Re: Griegos Farm/ 1860 Griegos Rd. NW
Request for Certificate of Occupancy- Phase I
Transportation Development Final Inspection
Architect's Stamp dated 06-14-22 (F13-D028A)
Certification dated 11-05-24

DRAINAGE AND TRANSPORTATION INFORMATION SHEET

Project Title: GRIEGOS FARMS **Building Permit #** BP-2023-48274 **Hydrology File #** _____

TCL- TRAFFIC CONTROL LAYOUT SITE PLAN

TCL1

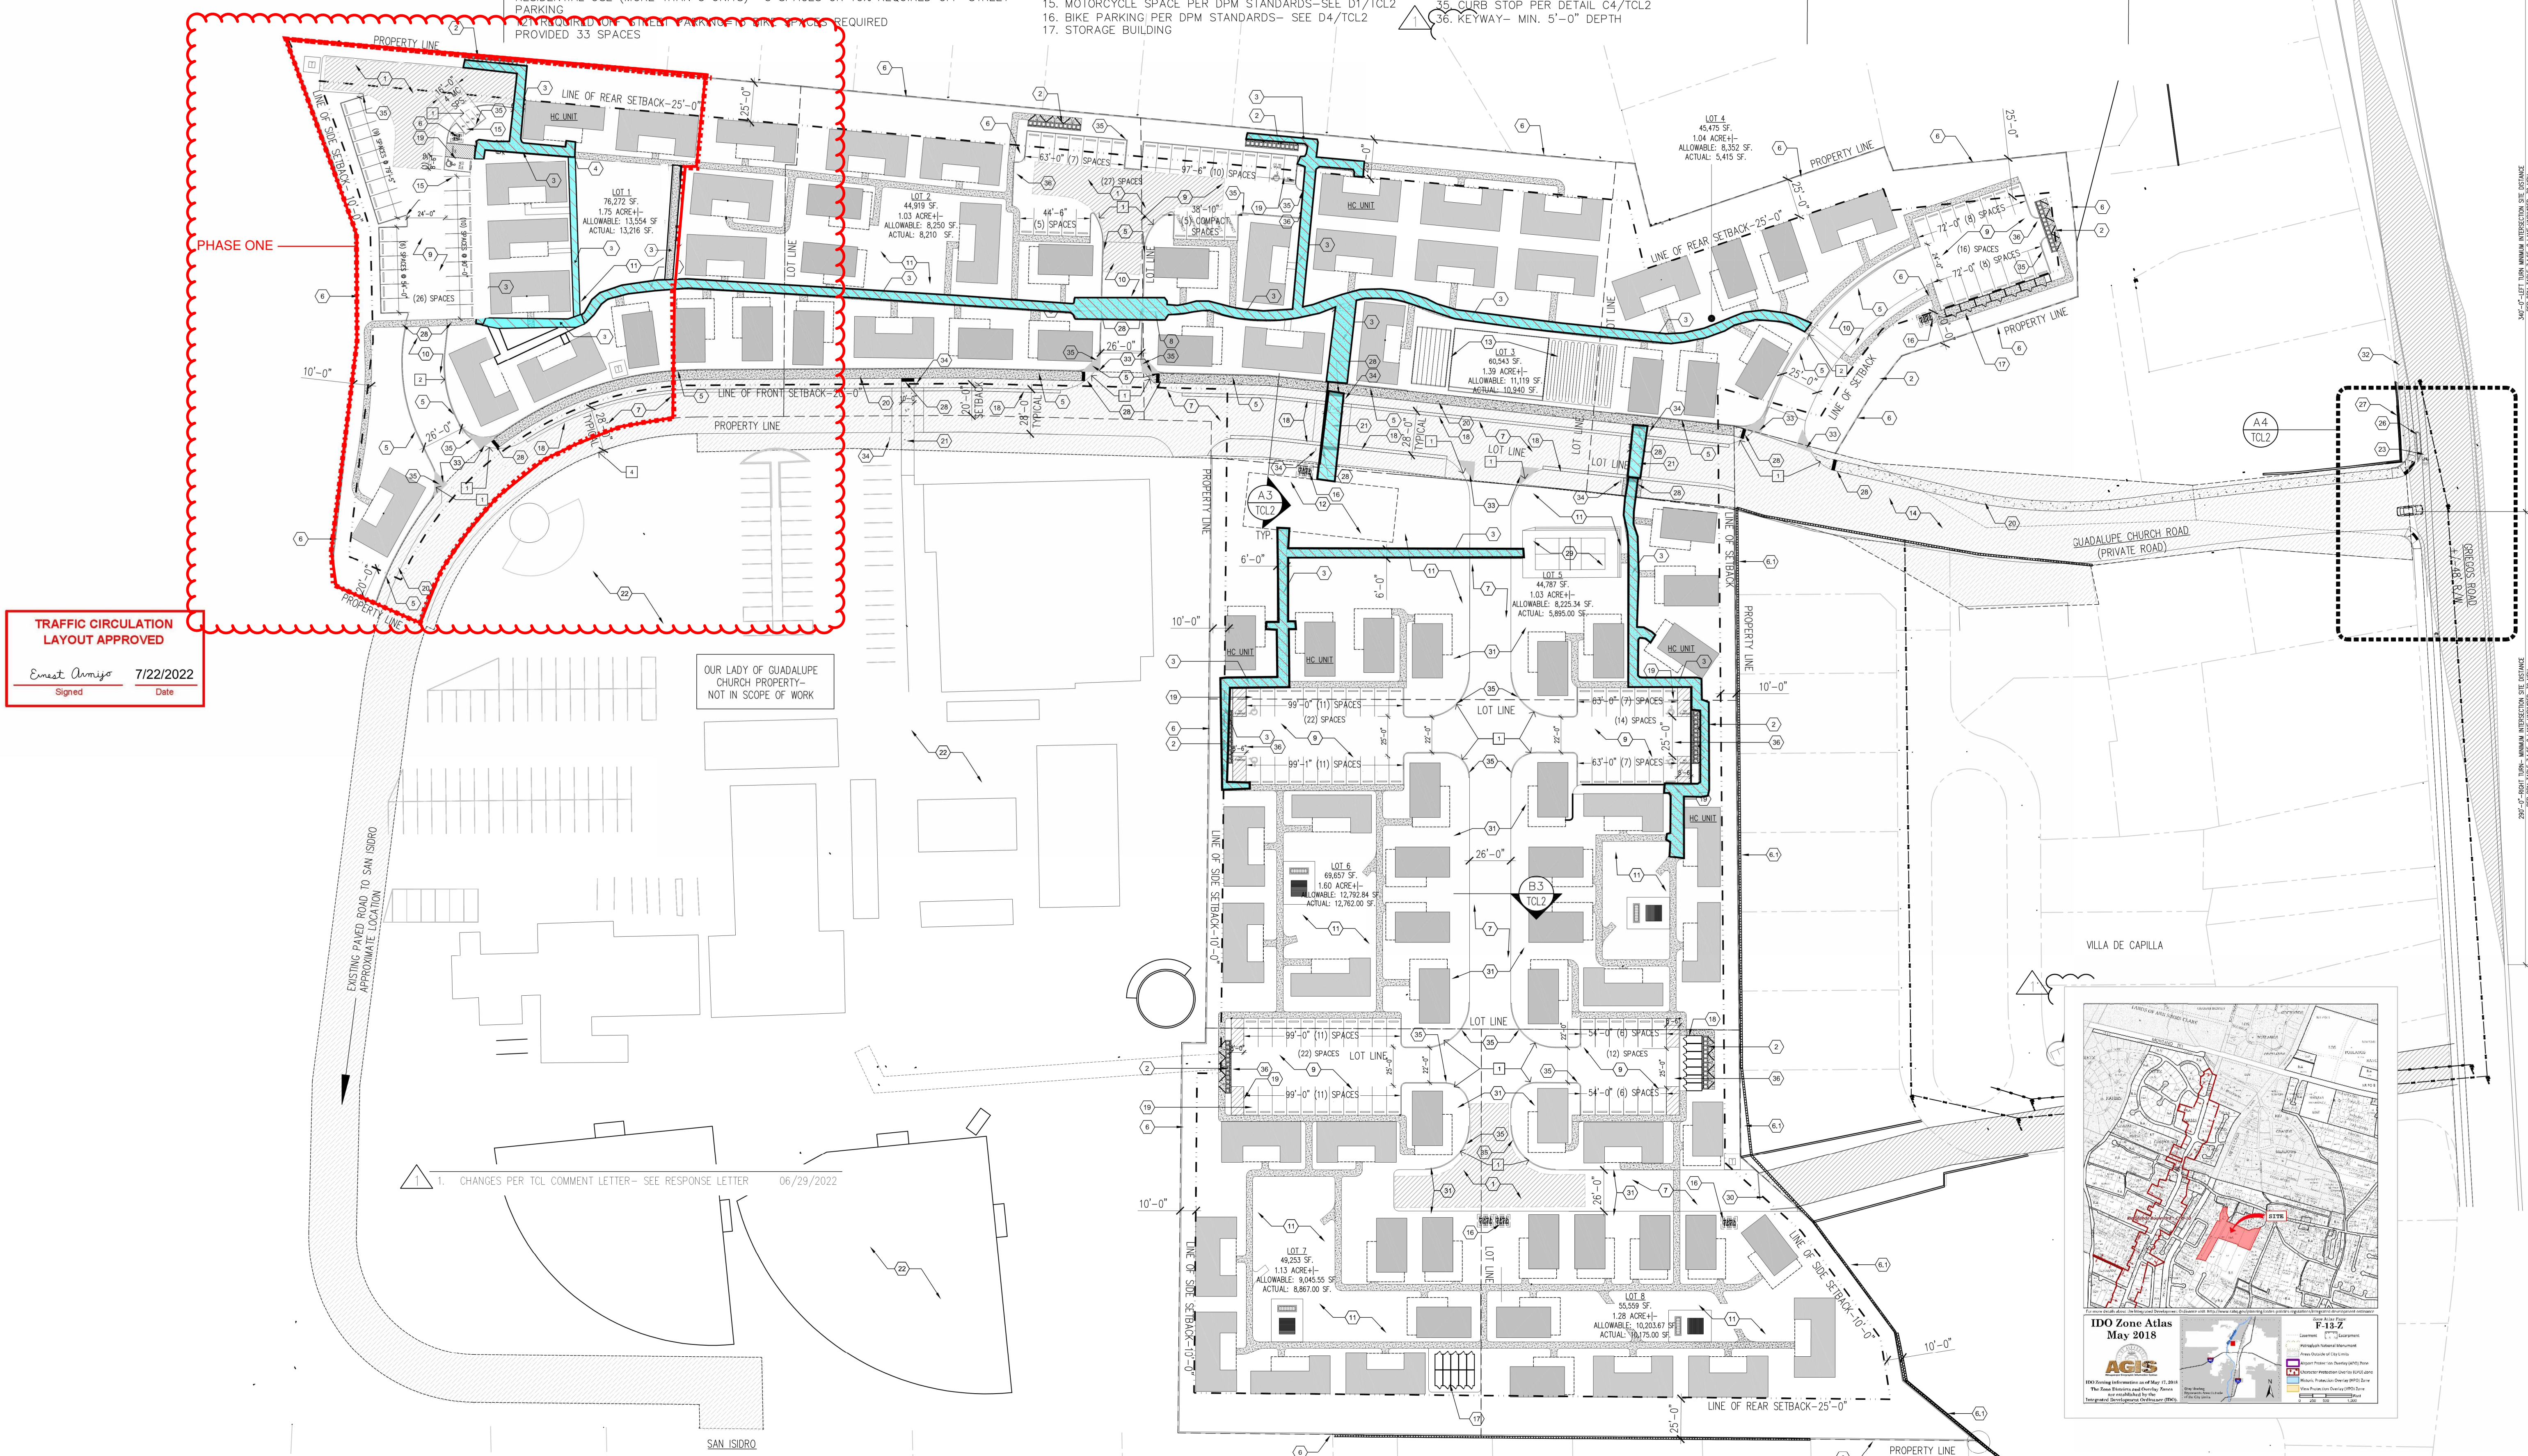
Based upon the information provided in your submittal received 11-05-24, Transportation Development has no objection to the issuance of a Permanent Certificate of Occupancy. This letter serves as a "green tag" from Transportation Development for a Permanent Certificate of Occupancy to be issued by the Building and Safety Division. **THE CONSTRUCTION OF THE MISSING PORTION OF THE SIDEWALK AT THE SOUTHEAST SIDE OF THE SITE IS A CONDITION FOR RELEASING THE FINAL CO FOR PHASE 2.**
